PLANNING REPORT

Planning and Zoning Commission

The Beacon Phase 1 25-119FDP

Address	PIDs: 273-008405, 273-008761
Proposal	Request for review and approval of a Final Development Plan for Phase 1 of the Beacon Continuum of Care Retirement Community, including site improvements, a water meter building, and a 4-story building containing 141 independent and assisted living units with underground parking. The 21.523-acre site is located northeast of the roundabout at Bright Road and Emerald Parkway.
Request	Request for review and approval of a Final Development Plan under the provisions of Zoning Code Section 153.055.
Zoning	PUD, Planned Unit Development District: Beacon CCRC
Planning Recommendation	<u>Approval of a Final Development Plan with Conditions</u>
Next Steps	Upon approval of the FDP by the Planning & Zoning Commission (PZC), the applicant may apply for site and building permits.
Applicant	Steve Newcomb, Newbury Companies
Case Manager	Bassem Bitar, AICP, Deputy Director of Planning (614) 410-4635 bbitar@dublin.oh.us

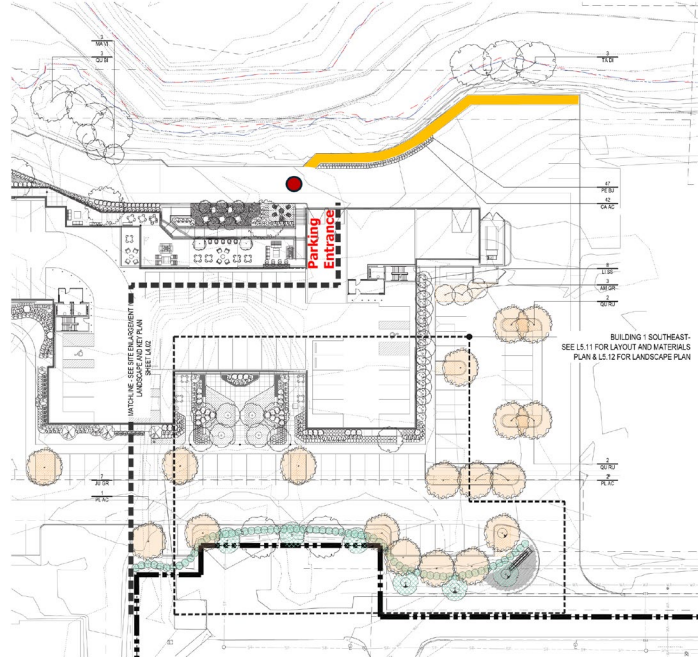
As noted above, PZC recommended 8 conditions of approval as part of the PDP review. Four of those were addressed prior to Council's approval of the rezoning and PDP, while the rest were intended to be addressed at FDP. One of those remaining conditions (Condition 3) was that the on-site alignment of the entry drive off Bright Road should be further refined to minimize conflicts, add a focal point, and achieve a more curvilinear design. The current plan addresses

this condition to staff's satisfaction by incorporating a traffic circle at the intersection of this drive with the east-west internal drive to better organize the circulation pattern, especially near the drop off area in front of Building 4. A variety of landscape materials would be incorporated within the circle to achieve the focal point objective.

The emergency vehicle access drive on the north side of the site would also provide access to the underground parking and the enclosed trash/delivery areas of Buildings 1, 3, and 4. Such activities are limited to one location at the end of each building, meaning the majority of the drive would be free of vehicular traffic and would double as a walking path. In order to maintain safe pedestrian access, another PDP condition (Condition 5) stipulated that separated pedestrian paths be provided along portions of the emergency access drive where entries to the structured parking are located. The applicant has addressed this condition by introducing a 6'-wide path near the northeast corner of Building 1, separated from the rest of the pavement by a combination of striping and a planter (shown in orange on the above graphic). The path will eventually provide a connection to the courtyard on the north side of Building 3. A similar treatment will also be incorporated at Building 4. This complements the rest of the proposed pedestrian circulation plan, which includes 6'-wide sidewalks and walkways throughout the site.

In order to prevent non-emergency vehicles from using the emergency access drive, the applicant has included a note on the site plan that a traffic barrier would be incorporated west of the parking garage access and coordinated with the Fire Department. Staff recommends the use of removable or retractable bollards in order to maintain pedestrian access (location shown in red dot on above graphic) subject to review and approval by the Washington Township Fire Department.

- 1) That removable or retractable bollards be used to restrict non-emergency vehicle use of the access drive on the north side of the site subject to review and approval by the Washington Township Fire Department.
- 2) That the applicant continue to work with staff to address site engineering and utility details including the sanitary sewer alignment and calculations to the satisfaction of the City Engineer.

Signage
Ground Signs

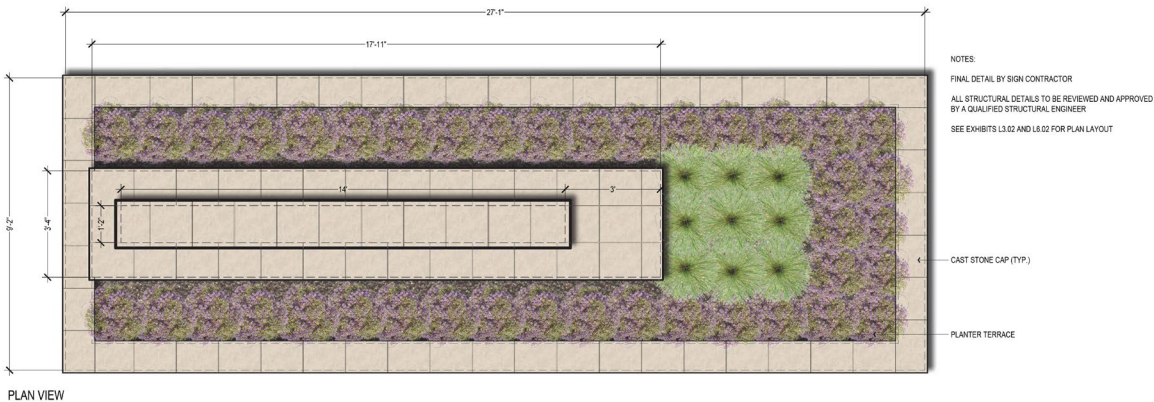
The applicant is seeking approval of a double-sided project identification ground sign at each of the two entrances to the site (off of Bright Road and Sawmill Road). Each would consist of a sloped split-face limestone-veneer face with a 4" cast stone cap and black pin-mounted, halo-lit letters. The sign base would extend beyond the front edge of the sign and would be clad with brick veneer with a limestone cap. The entire structure would be surrounded by a raised planter, also with a brick veneer and limestone cap. The brick would match one of the colors used for the buildings within the development. Plant materials would be placed within and around the planter. At its highest point, the sign would be 6'-6" above grade, tapering down to 5'-6" at the other end. The letters forming the project name would be 1'-3" in height and 8'-6" in width for a message area of slightly less than 11 square feet. The site's address would also be incorporated and would consist of 6"-tall numbers and letters. The proposed development text language states that the graphic area would not exceed 16 square feet per sign face and provides the option of halo lighting and ground-mounted lighting. The language also states that the front edge of the sign face must be located a minimum of 8 feet from the right-of-way line. This setback is consistent with code requirements and is reflected in the site and landscape plans.

The proposed ground signs deviate from code standards in several respects. Nursing homes are entitled to a single ground sign with a maximum sign area of 15 square feet and a maximum height of 6 feet. Code allows a second sign if the site has two public right-of-way frontages and there is a minimum separation of 100' between the two signs, which applies in this instance. However, when two signs are permitted, code limits the total combined area of both signs to one and one-third times the maximum permitted area of a single ground sign.

Similarly, the total combined height cannot exceed one and one-third the maximum permitted height of a single ground sign. This translates to a maximum combined sign area of 20 square feet (10 square feet per sign) and a maximum combined height of 8 feet (4 feet per sign). Staff is supportive of the proposed departures from the code requirements for sign height and area due to the significant distance between the two project identification signs and the presence of an existing office park occupying the frontage of both streets between the entrances to the proposed development. It should also be noted that other types of uses along those roadway frontages are entitled by code to larger and taller ground signs

The applicant is also proposing an additional single-sided ground sign at the vehicular access to the site from the access drive shared with the office park to the south. The design and size is identical to the roadway frontage signs except that no planter would be included in this instance. As such, the height at the tallest point would be 5'-2". Staff is also supportive of this sign as it is internal to the site and not intended to be visible from the public right-of-way.

1. Reduction of the pavement setback from the Emerald Parkway right-of-way to 90 feet at the westernmost traffic circulation circle.
2. Addition of signage standards.
